OYSTER CREEK NUCLEAR GENERATING STATION UNIT NO. 1

AMENDMENT TO PROVISIONAL OPERATING LICENSE

Amendment No. 6
License No. DPR-16

CHANGE NO. 22 TO THE TECHNICAL SPECIFICATIONS

OYSTER CREEK
ALLOWABLE DRYWELL TO NETWORK LEAKAGE CAPACITY
VS PRIMARY SYSTEM BREAK AREA

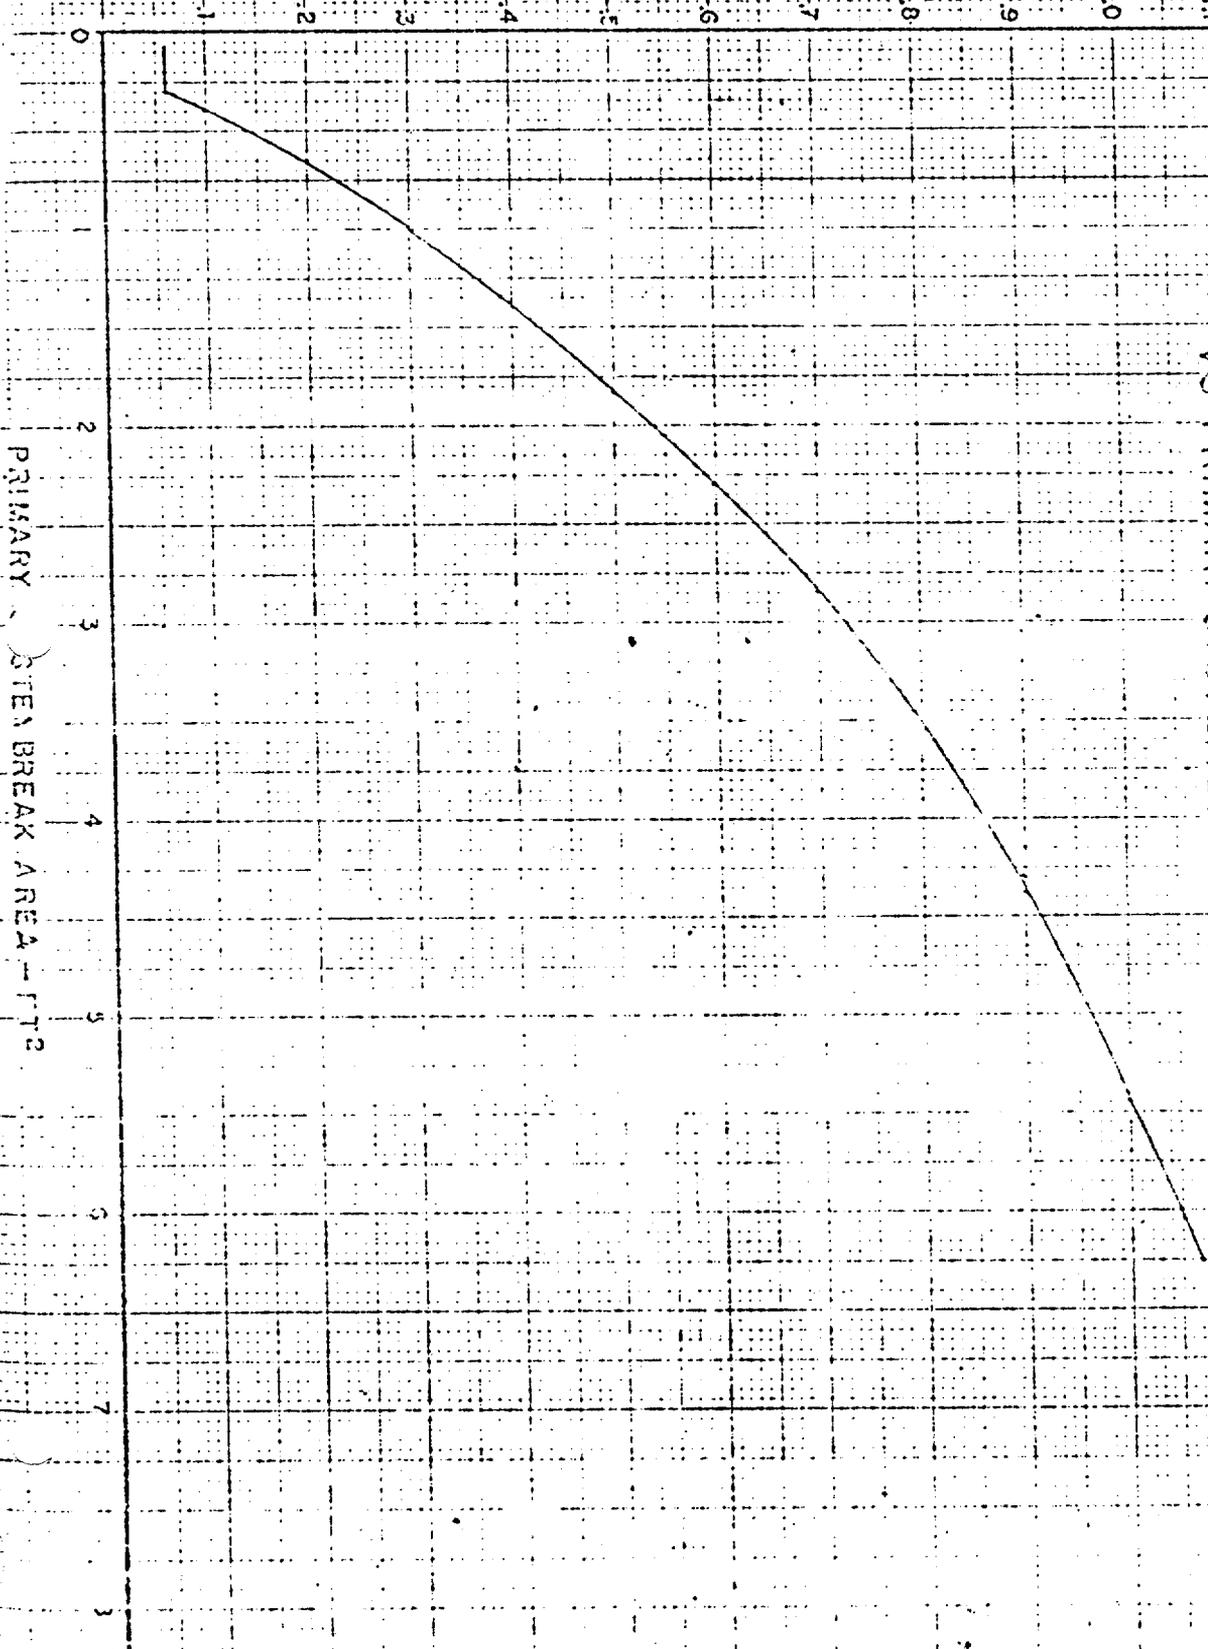
A small break in the primary system concurrent with an excessive leakage path between the drywell and suppression chamber could result in an internal pressure that would exceed the structural capability of the primary containment. The results of the analysis for bypass leakage capacity vs. primary system break area shown in Figure 1 were prepared by General Electric Company (GE), and presented in JCPL's letter dated May 28, 1974. For break areas of less than about 0.3 sq. ft., the pressure differential between the drywell and suppression chamber stabilizes at a value equivalent to the hydrostatic head (4 ft.) of water in the downcomer, i.e., 1.8 psi. Because the break is small, this situation may prevail for a relatively long time and thereby maximizes the steam bypassed into the suppression chamber air space. Since small breaks in the primary system have the potential for yielding the most severe pressurization, their associated bypass areas establish the limiting condition. From Figure 1, it can be seen that the maximum bypass leakage capacity which may be tolerated is $\frac{A}{\sqrt{K}} = 0.060$ sq. ft., i.e., the limiting

region of the curve; this value is equivalent to a vacuum breaker bypass area of about 10.5 sq. in. and a plate orifice flow area of about 0.1 sq. ft. (4.2 in. diameter). Based on the 10.5 sq. in. bypass opening developed above, the maximum amount that any one vacuum breaker could be off its seat is 0.371 inch. This arc length corresponds to an angular displacement of 1.25°.

The suppression chamber drywell vacuum breaker limiting condition for operation has been established as an opening not greater than 0.10 in. This condition requires that a faulty vacuum breaker be considered inoperable and immediately locked closed. The allowable minimum number of operable vacuum breakers is established from data obtained during pressure suppression tests performed by GE.^{1/} In Amendment 15 of the Oyster Creek FDSAR, Section II, the licensee states that an area of 2920 sq. in. for flow of non-condensable gases from the suppression chamber to the drywell is the minimum required area. To conform with this requirement, at least (minimum) 12 of the 14 vacuum breakers (18" diameter) must be operable. The reactor must be shutdown if more than two vacuum breakers become inoperable and are secured in the closed position. The technical specifications will be revised to include this limitation. Inasmuch as the 2920 sq. in. area for flow of non-condensable gases from the suppression chamber to the drywell is maintained under the proposed change, there is no decrease in the margin of safety.

Tests to verify acceptable leakage from the drywell to the suppression chamber should be performed during each refueling outage. This surveillance requirement will be included in the technical specifications. The allowable bypass area from the drywell to suppression chamber, as stated above, is that area equivalent to an orifice with a diameter of approximately 4.2 in. JCPL has specified that the maximum allowable leakage from the drywell to the suppression chamber, during tests, should be equivalent to flow through a 2-inch diameter orifice with an initial differential pressure of not less than 1 psi. This is an acceptable test limit for leakage and will be included in the technical specifications.
